LICK RING WALL RECEIPT INSPECTION REPORT

1. LICK RING WALL RECEIPT INSPECTION

The initial ring wall receipt inspection was carried out on Wednesday 24/11/2004 with a follow up inspection on the 8/12/2004, at The Railways Workshops in Goulburn. A full survey of the ring beam, plus metrology of all finished parts was carried out by Mark Elphick and Jason Chapman on the 24/11/2004. Personnel present for the follow up inspection were Mark Elphick and Robert Paragalli. The principle contractor Ken Ainsworth was in attendance for both receipt inspections.

Figure 1-3 Diagonal Braces

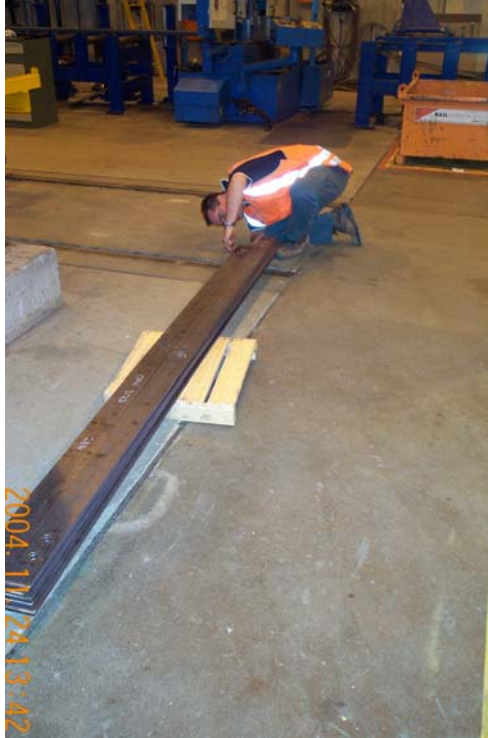
Quantity 20-all dimensions within specifications outlined in drawing MDD 03128.

The fastener holes require de-burring.

All sections have been de-burred. Dimensions are all within specifications-see first RI.

Figure 1-6 Incomplete equipment door

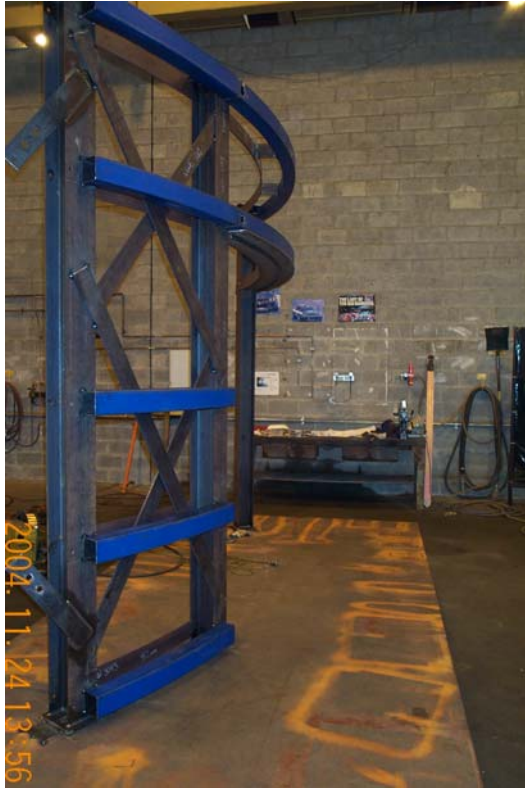
The door assembly and ring wall column double were incomplete and will be revisited when the second RI is scheduled. See Chapter 2

Figure 1-7 Misaligned cross brace support tabs

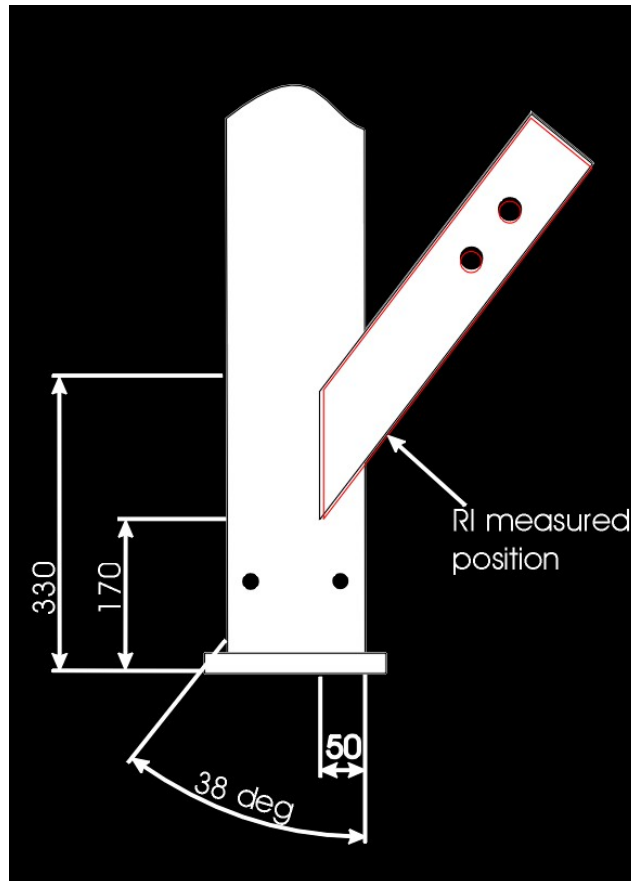
A problem was encountered with the ring wall column balcony supports. The attachment cross brace support plates were shortened by 5mm to accommodate the weld fillet between the cross brace support plate and the balcony support plate, resulting in the tab being misaligned by 6mm vertically.

The tabs will not require repositioning as the problem can be addressed during construction. However it does highlight the problems that can be created if verification is not obtained prior to altering fabricated parts.

Figure 2-3 Z braces

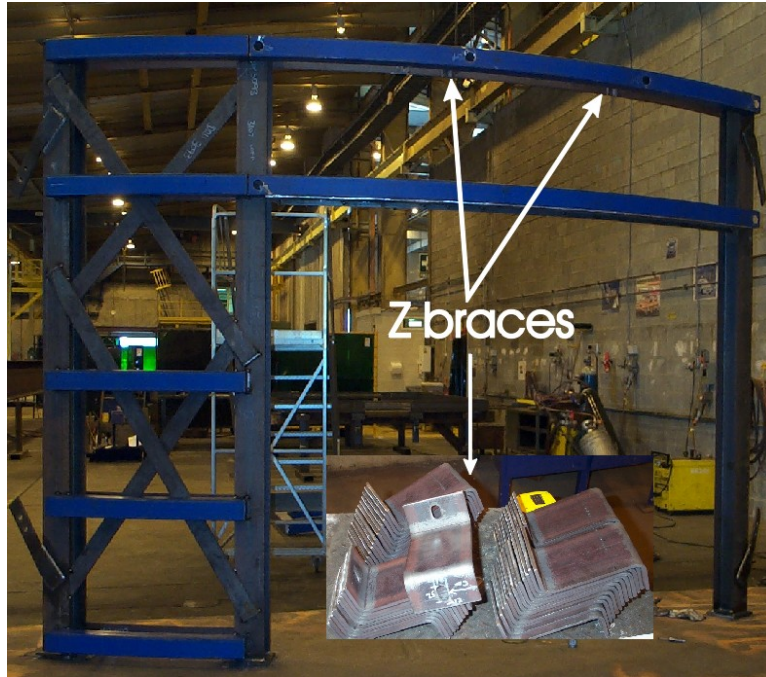
Initial RI there was two Z braces unaccounted for. The two missing Z braces are being used in the erected ring wall section that houses the equipment door – 52 in total.

Figure 2-6 Ring wall double column

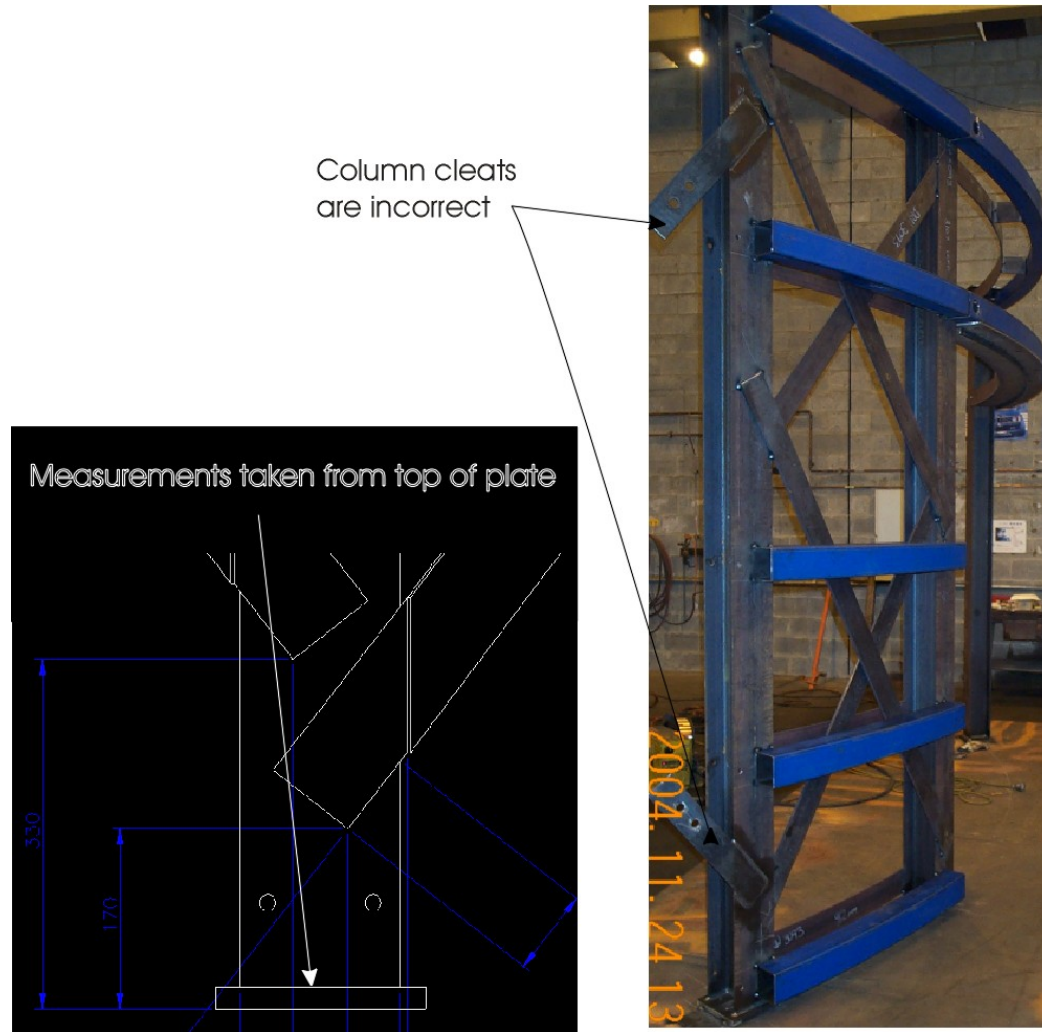
The column cross brace support tabs were the only problem on the double column. The measurements were taken from the inside of the column base plate and should have been measured from the outside of the plate (See Figure 2-6). Column cross brace support tabs need to be removed and re-welded in the correct position.

Figure 2-7 Single column

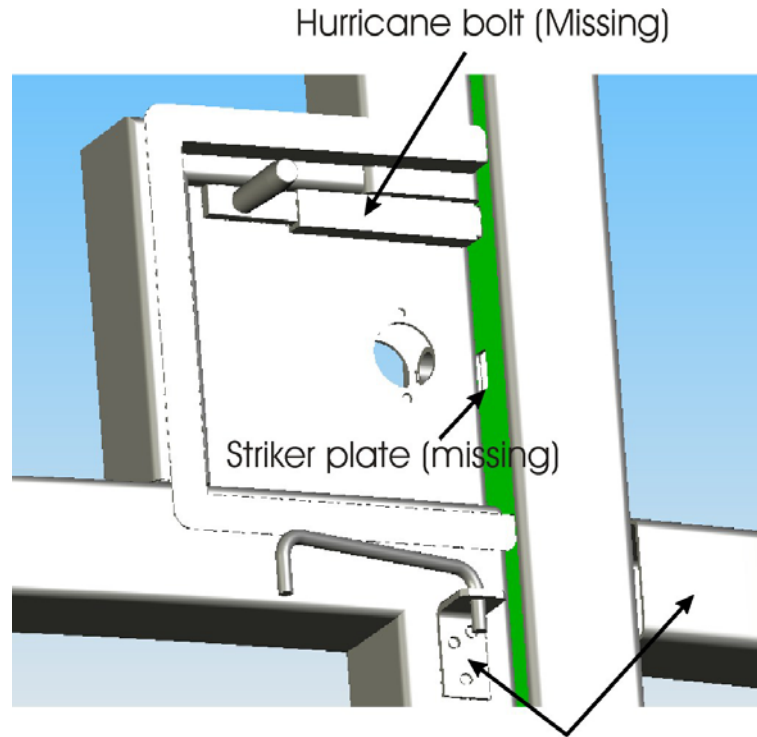
The column cross brace support tabs were the only problem on the single column. The measurements were taken from the inside of the column base plate and should have been measured from the outside of the plate (See figures 2-6 and 2-7). Column cross brace support tabs need to be removed and re-welded in the correct position. All other dimensions are as per specifications in drawing MDD 03348.
